B I D A D D E N D U M 0 4

The items set forth herein, whether of omission, addition, substitution, or clarification are to be included in and form a part of the construction documents for the project listed above.

ORANGE-ULSTER BOCES
AXELROD - MAIN
BUILDING
ADDITIONS +
ALTERATIONS
53 GIBSON ROAD
GOSHEN, NY 10924

5 EAVE DETAIL - LOBBY CANOPY SLOPED LOW END

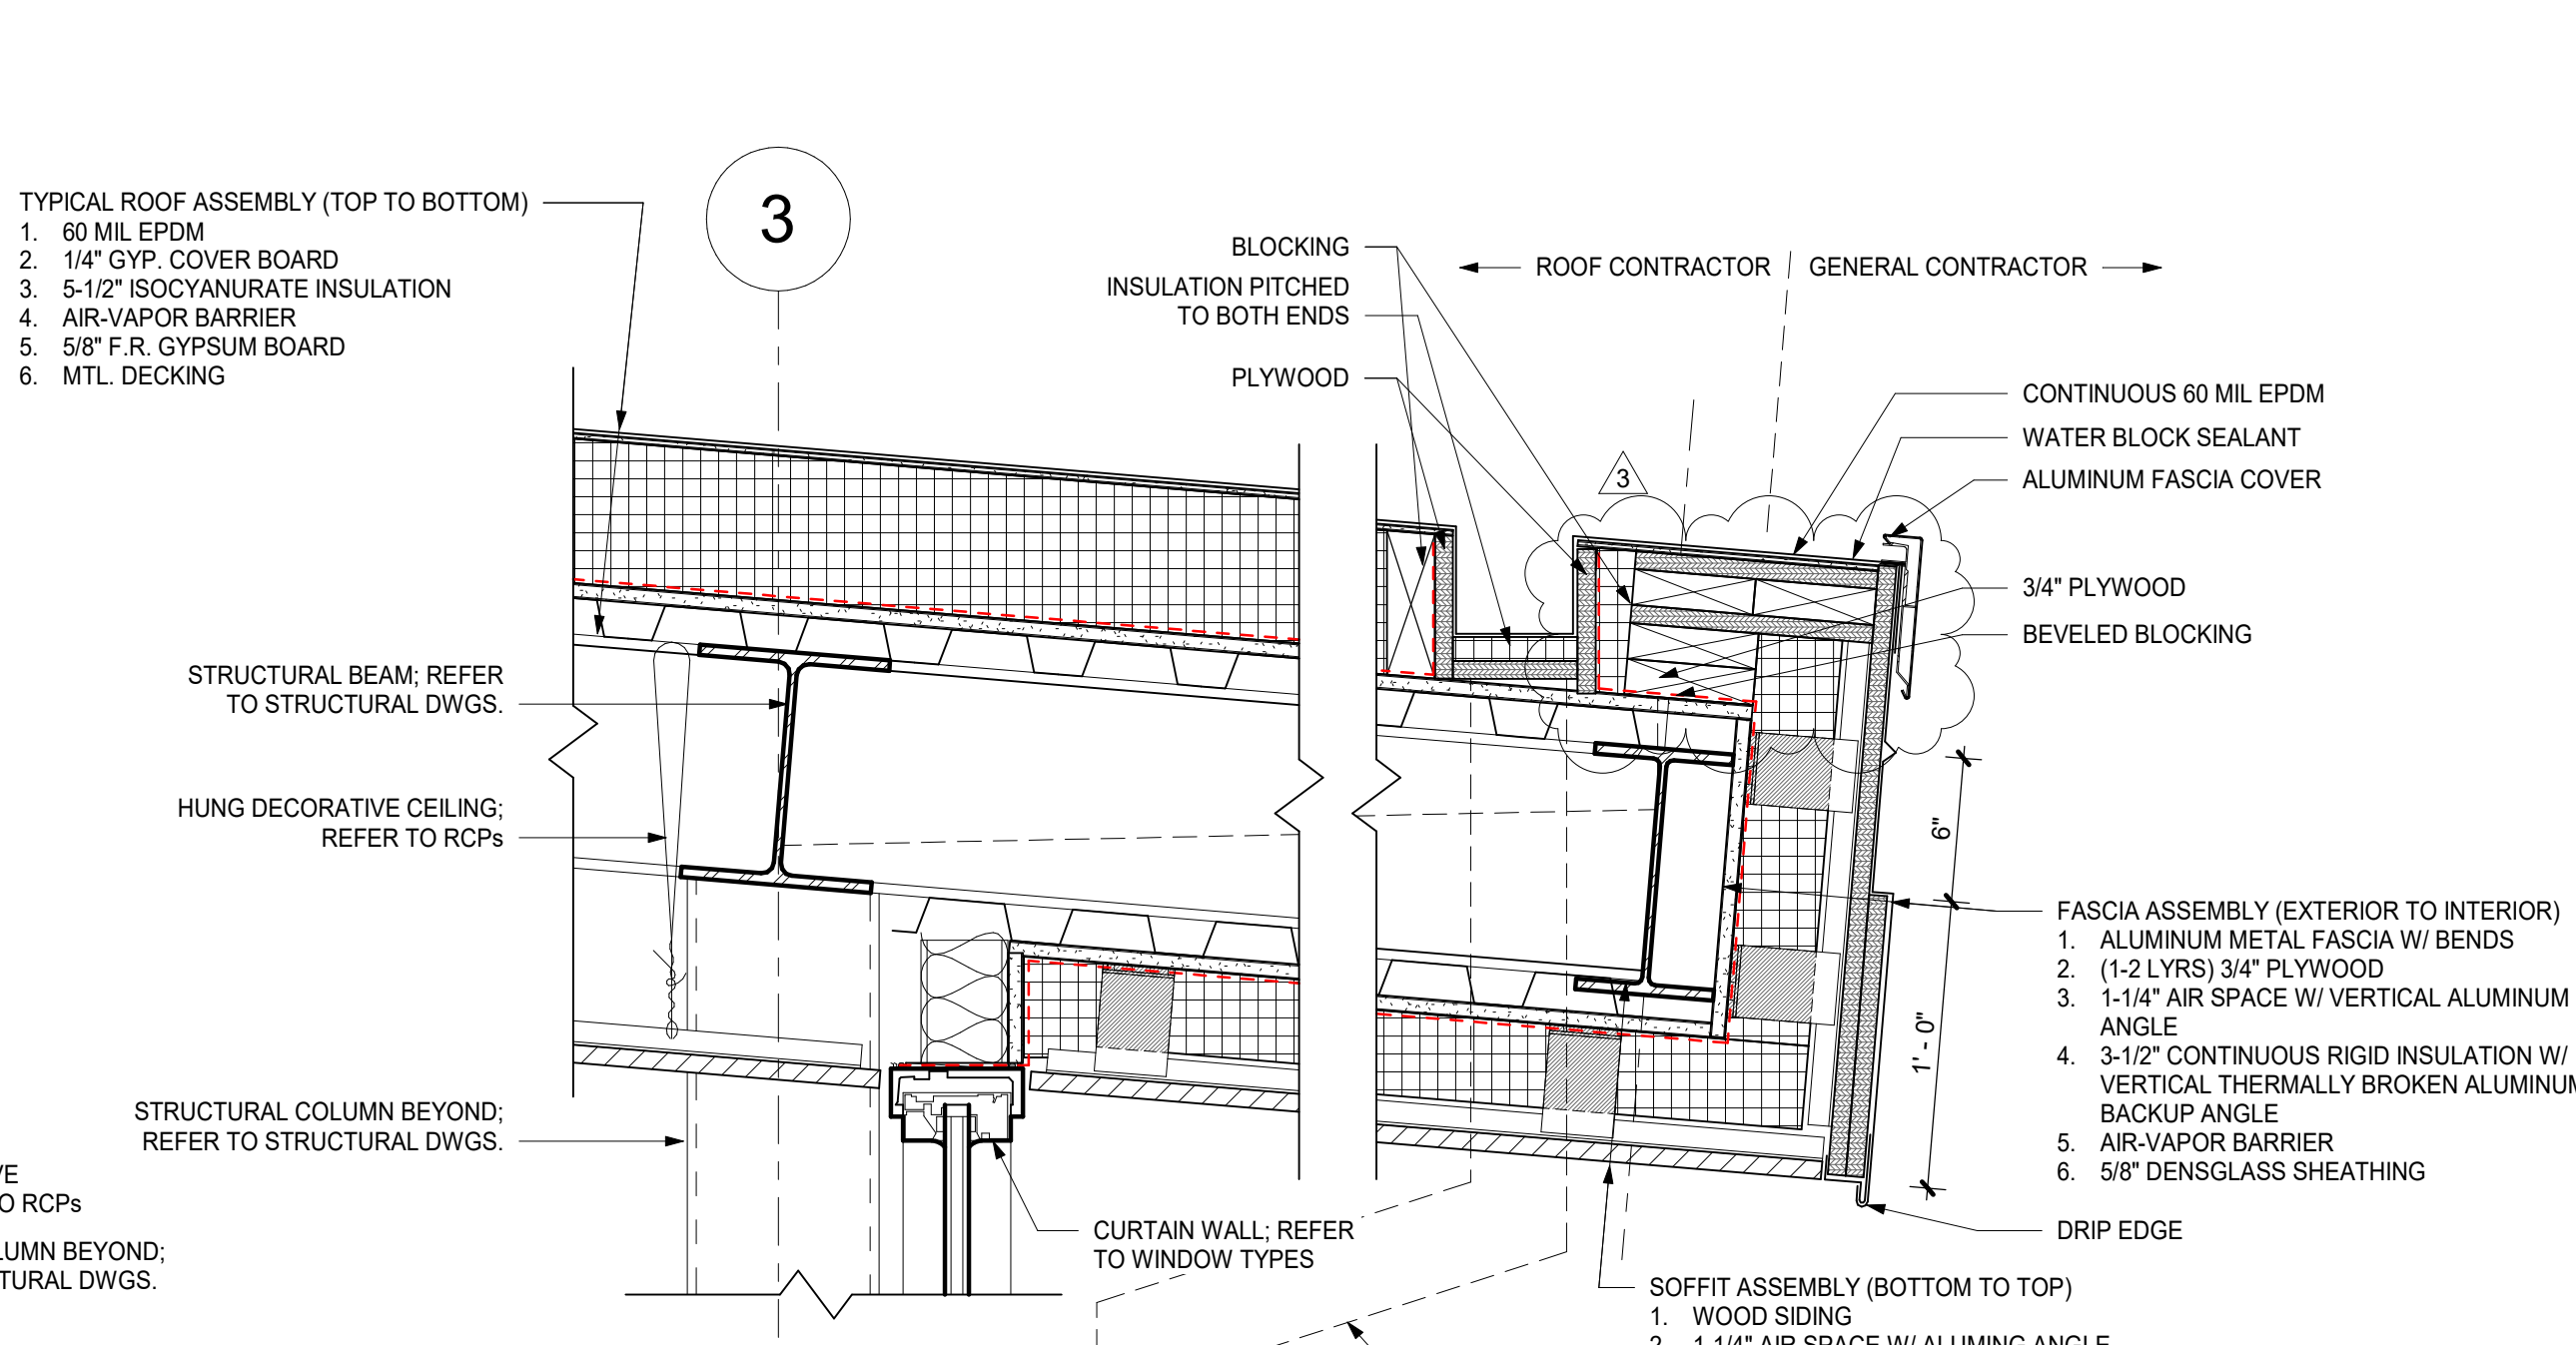
- 7.6 RFI Question – Reference 5/A806 & 4/A807, who owns providing and installing the built-in gutter blocking and sheathing? Is the gutter pitched, or is the roofer adding in tapered insulation?
RFI Response –
5/A806 – Roofing Contractor shall be responsible for gutter blocking and tapered roof

insulation at this gutter. Roofer shall provide the tapered insulation pitched to each end.
4/A807 – General Contractor shall be responsible for construction of this gutter assembly including the plywood and blocking, including the sloped plywood bottom. Roofing contractor shall be responsible for epdm, sheet metal fascia, cants, flashings, etc.
The Roofing Contractor shall be responsible for aluminum brake metal that wraps 1'-9" underneath the canopy at the perimeter to ensure it matches the fascia material. GC to provide the plywood backing and framing for this aluminum material.

10 SILL DETAIL - LOBBY CLERESTORY

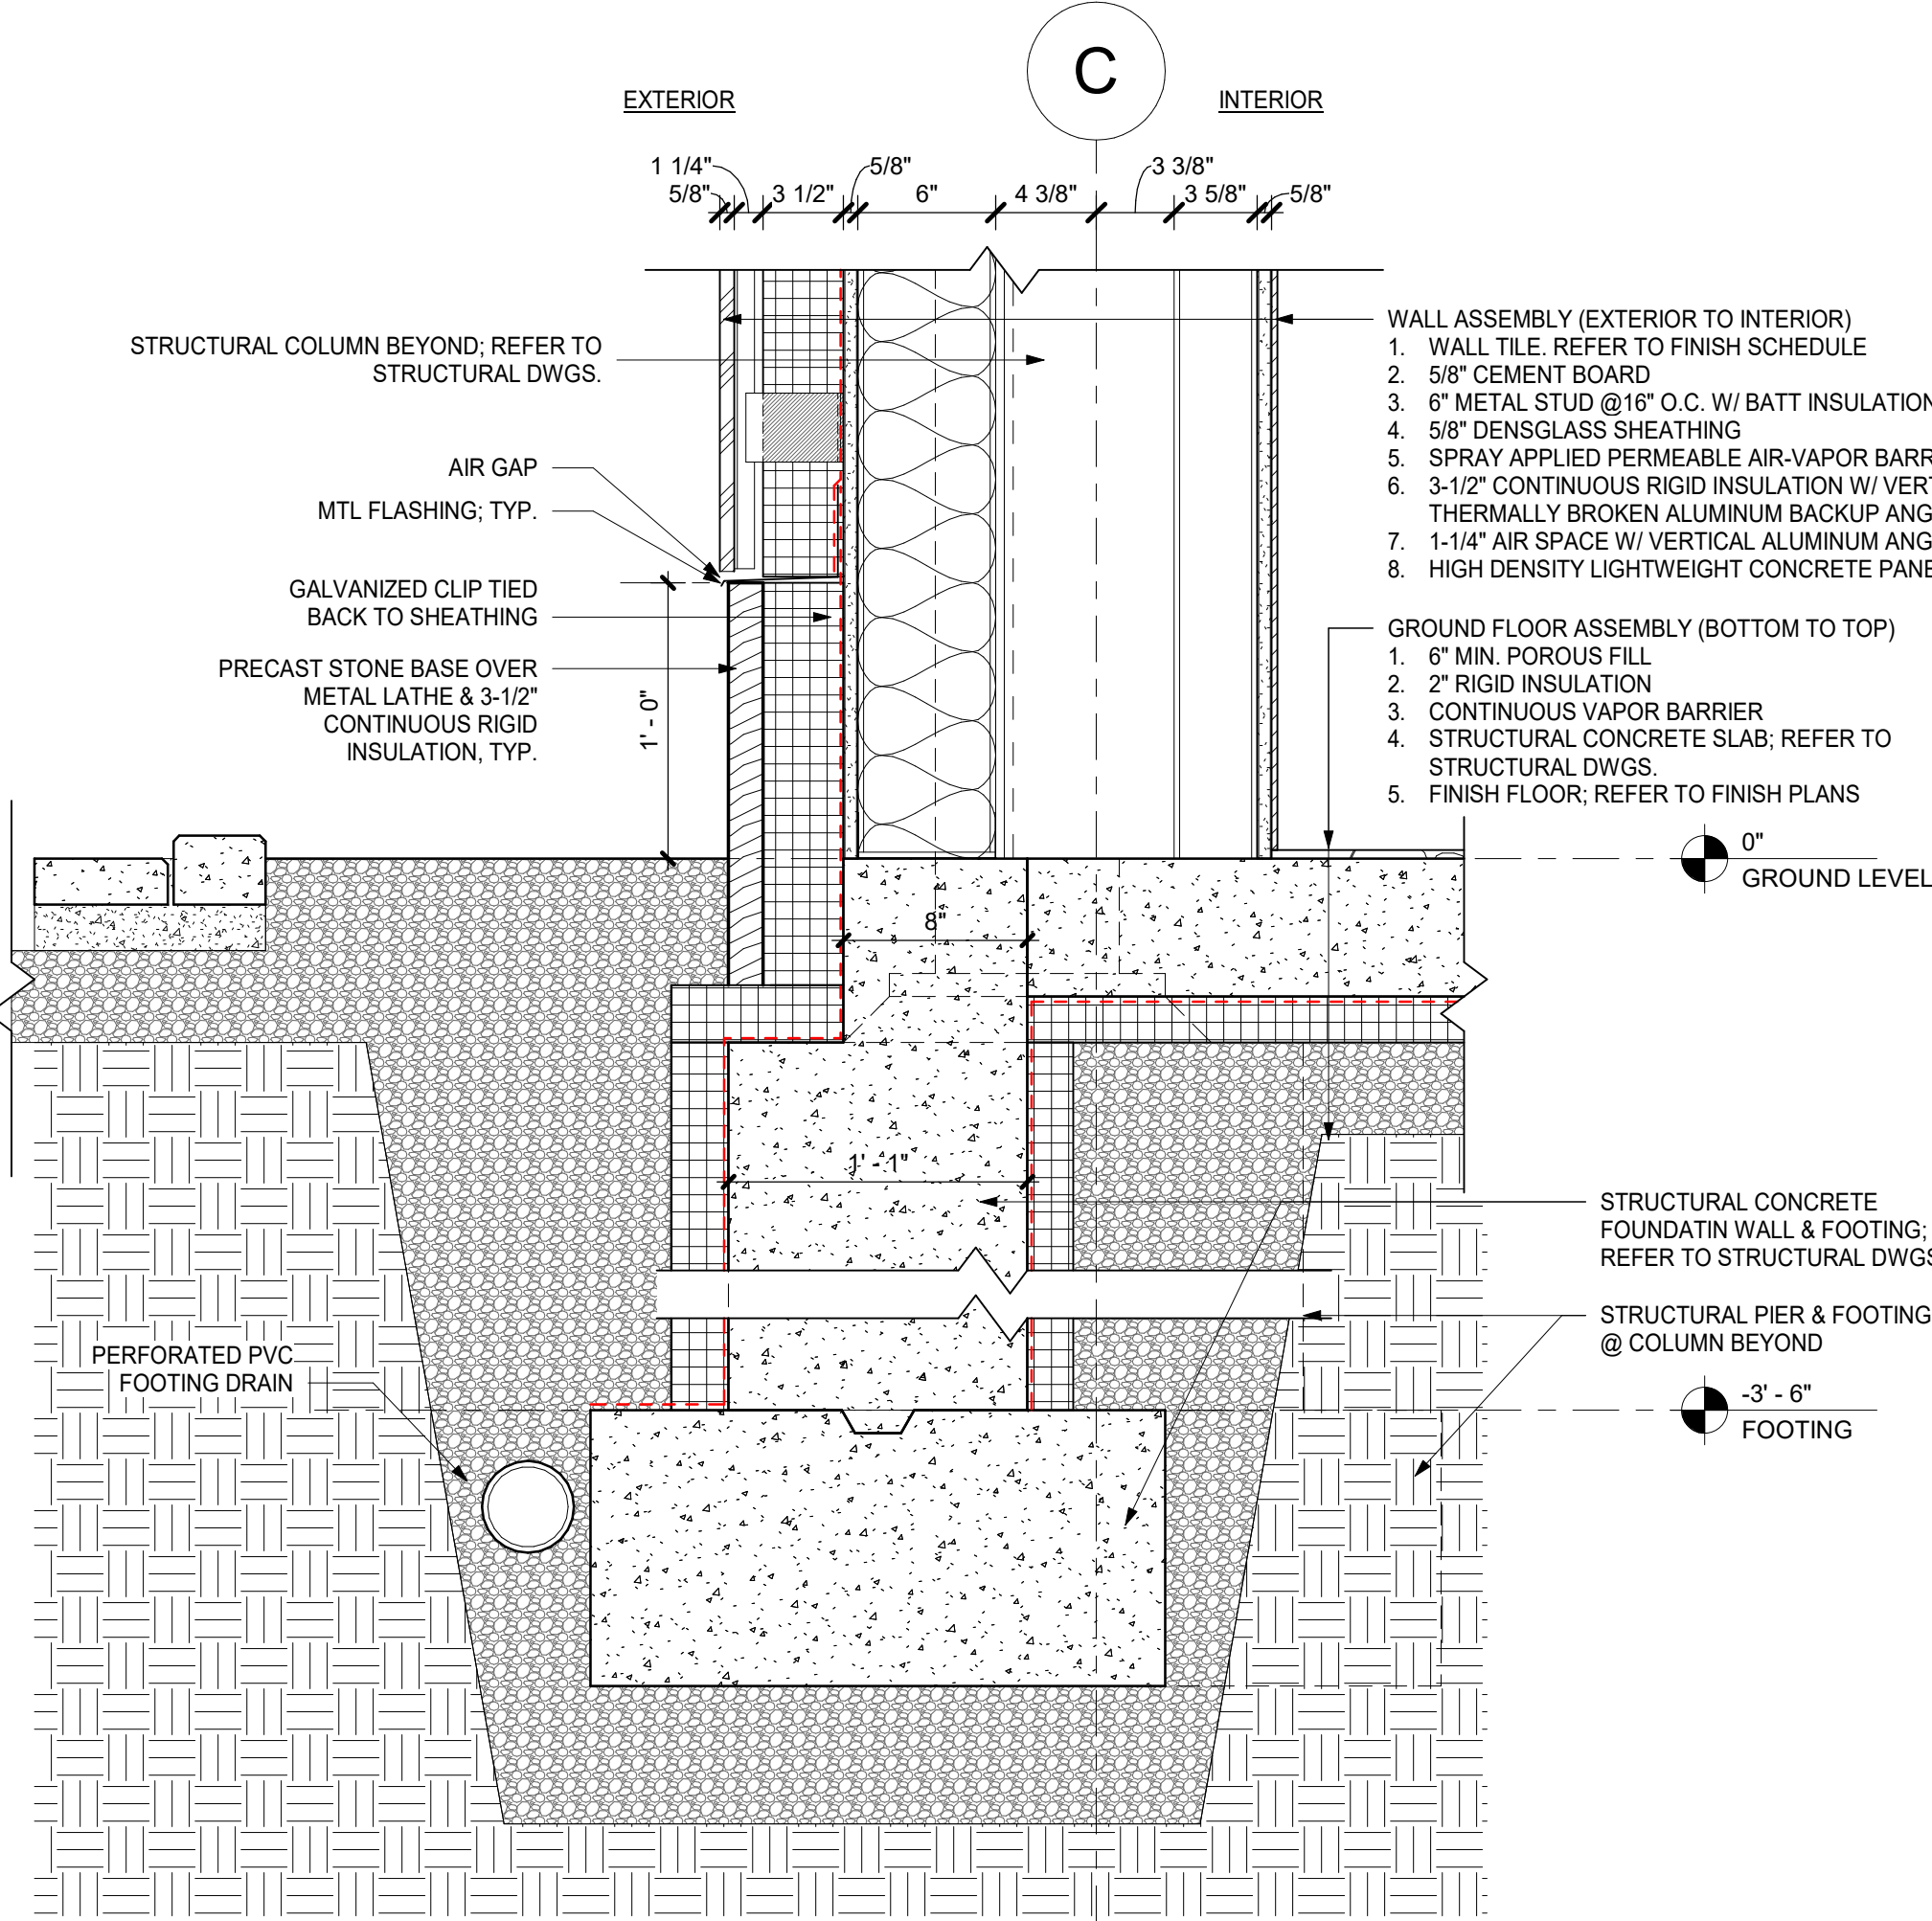
- 7.35 RFI Question – FRP is called out in 10/A806 but there is no FRP section in the spec book nor does it appear in the corresponding elevations – elevations show PT-6 on the walls at the clerestory glass. Which should be included?
RFI Response – These walls shall be tile per elevations. See also revised A806 included in this addendum. There is no FRP in the Lobby area.

4 EAVE DETAIL - CANOPY @ EXT. COLUMN
1 1/2" = 1'-0"

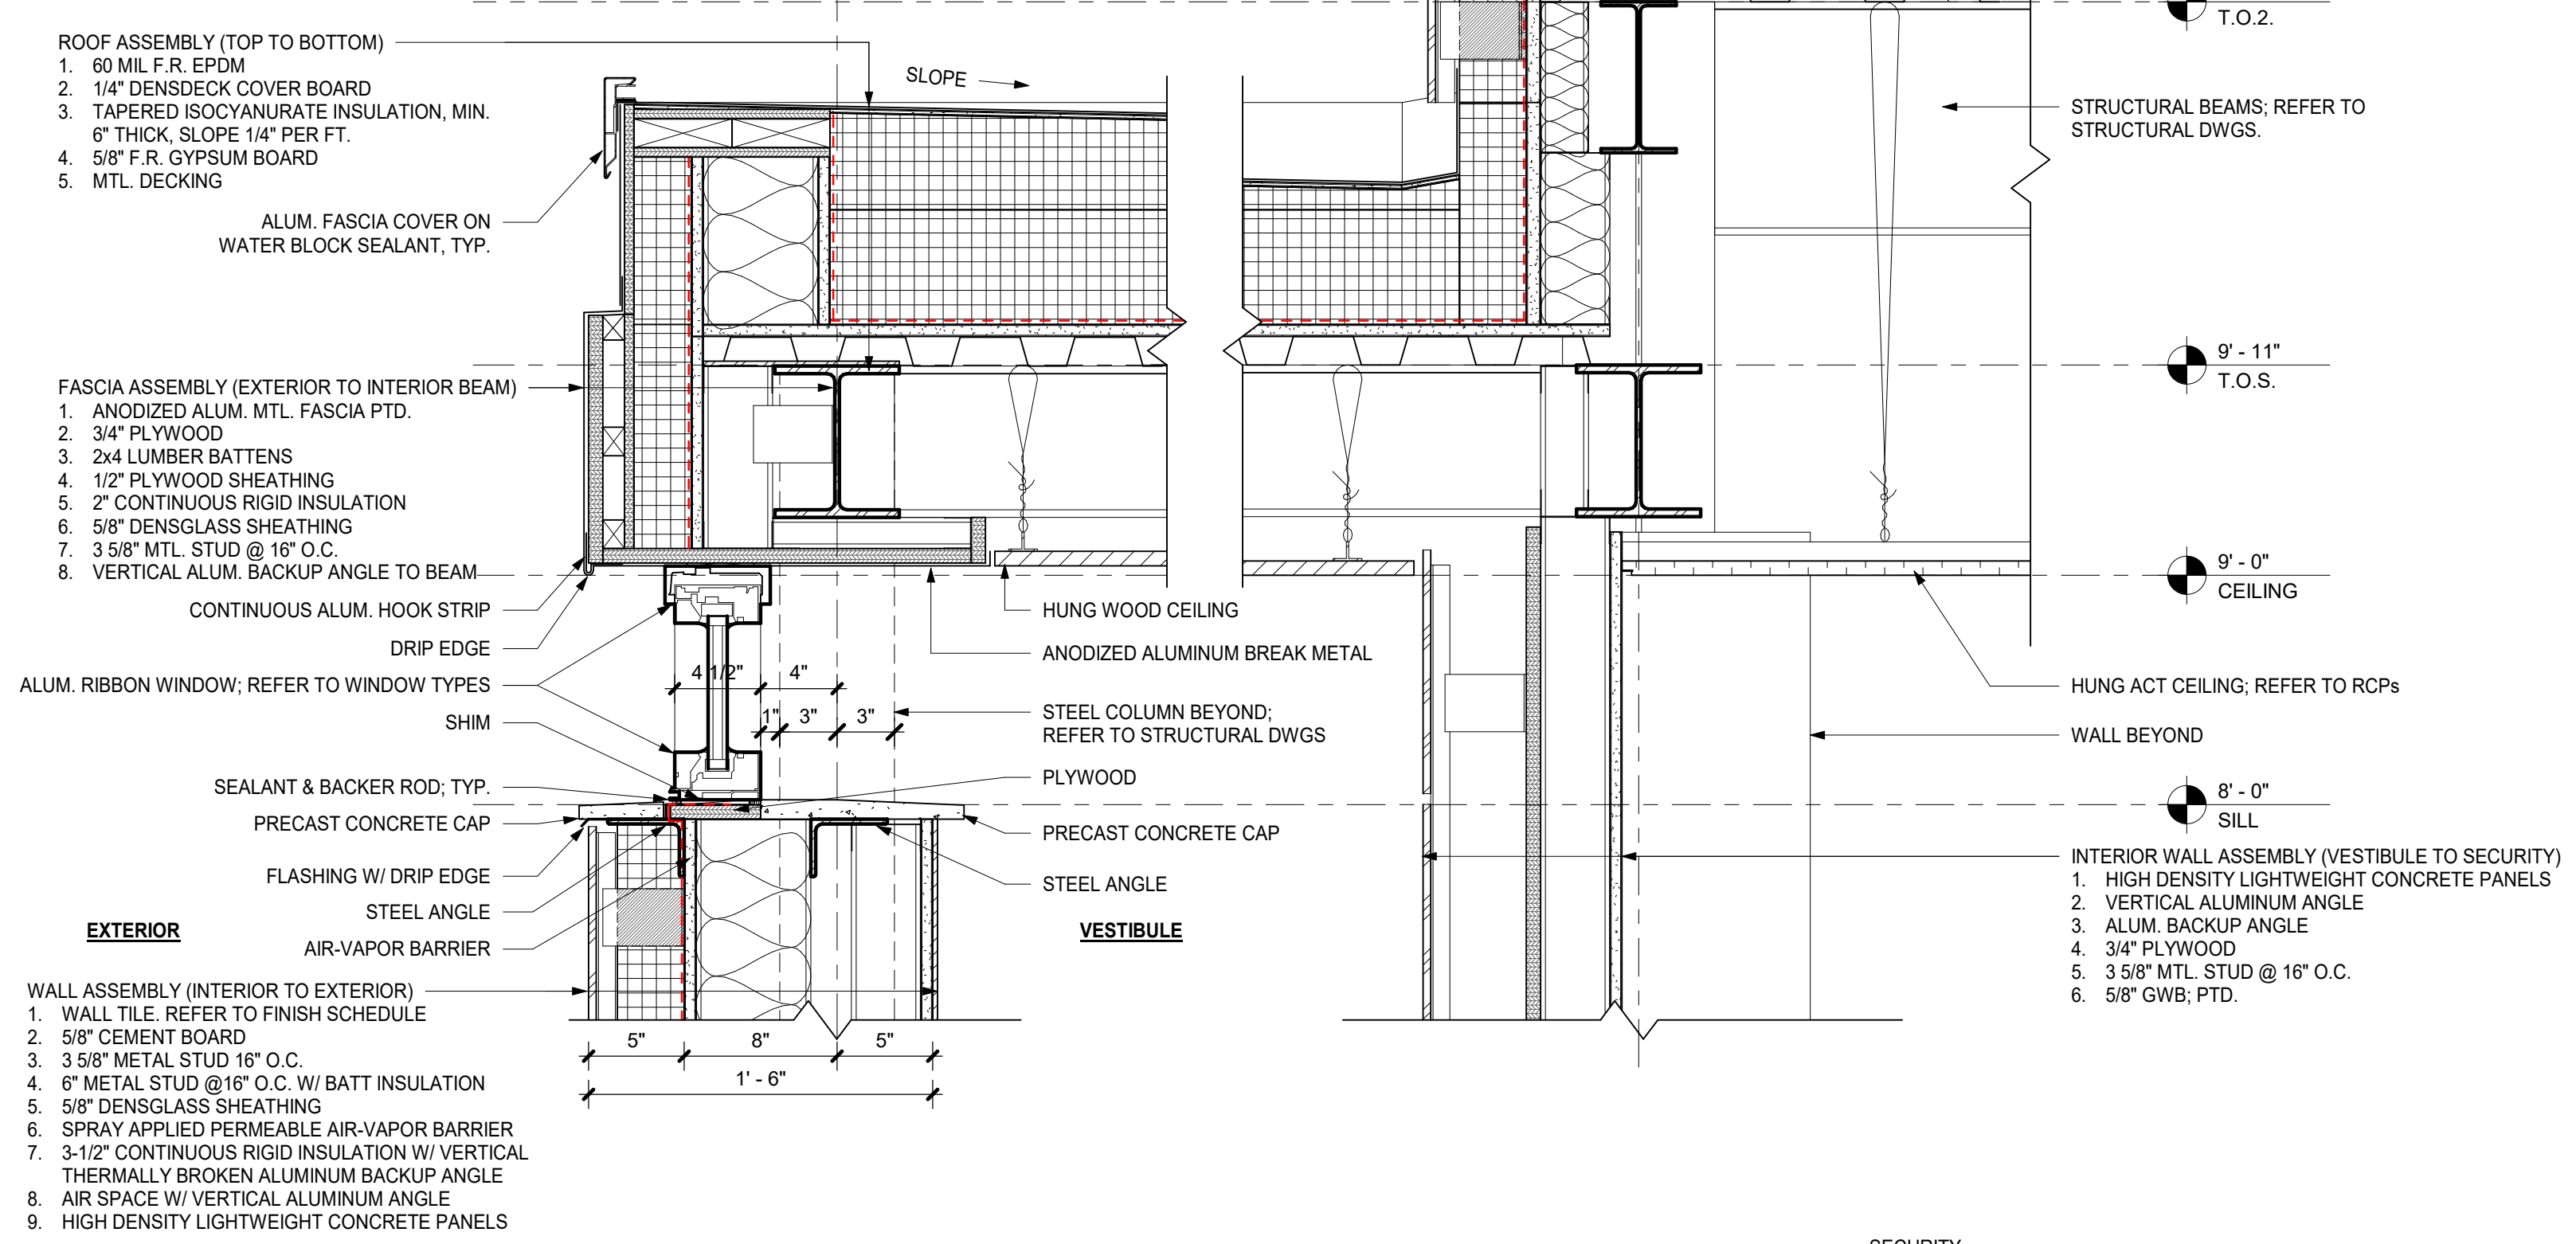
- b. Detail 4/A807 – Modifications to gutter assembly, fascia, and underside of canopy.
- 4.7 DRAWING L954A – Landscape Plan Add Alternate
- a. Omit notes referring to “Concrete Pavers”. The plaza shall be poured concrete and the triangular pattern (approximately 5foot sized triangles) shall be achieved with decorative sawcuts in conjunction with required control/expansion joints.
